| SUBJECT: DTC 72 AND 73 / TCL LIGHT COMING ON | | No: TSB-02-13-002 | |
| | | DATE: February, 2002 | |
| | | MODEL: 2001-02 Diamante | |

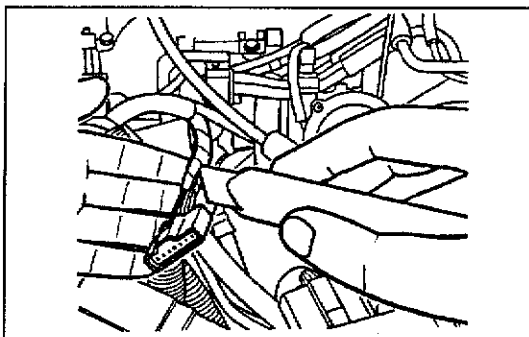
1. Remove the plastic engine cover.
2. Disconnect the 7-pin connector from the distributor.

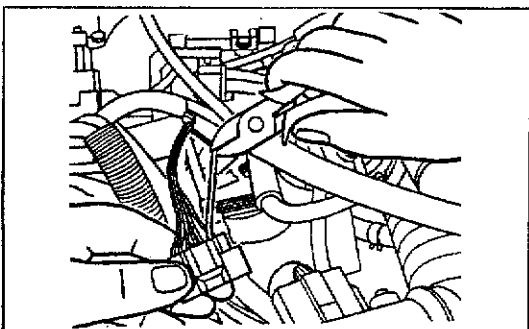
3. Use a sharp blade to open the plastic harness covering behind the main loom, to expose the wires.

4. At pin #2, cut the white wire 2 inches from the connector.

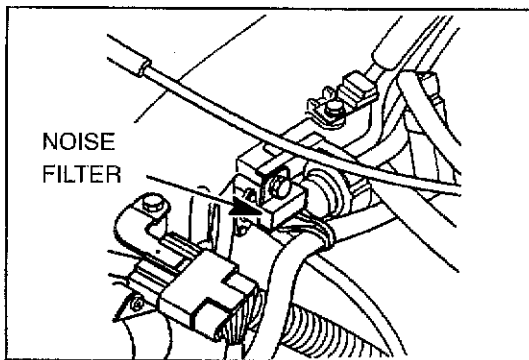
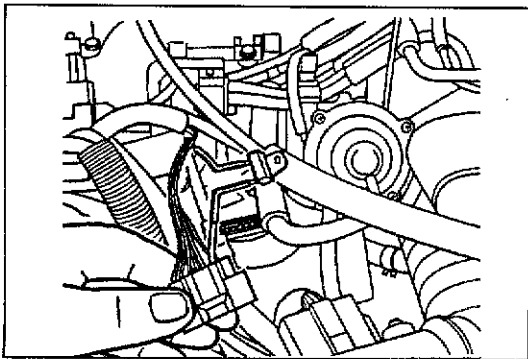
5. Install a noise filter (listed in the PARTS INFORMATION section of this bulletin) as shown.

Be sure that the wires are properly positioned before soldering, and that a clean, strong joint is formed.

- a. Solder the black wire to the connector side of the harness.
 - b. Solder the white/red wire to the harness lead.
 - c. Install heat shrink tubing over the soldered areas for insulation.
6. Reinstall the plastic harness covering and tape securely for a watertight seal.
 7. Position the noise filter between the vacuum control valve bracket and the bolt as shown.
 8. Reconnect the distributor connector.
 9. Reinstall the plastic engine cover.
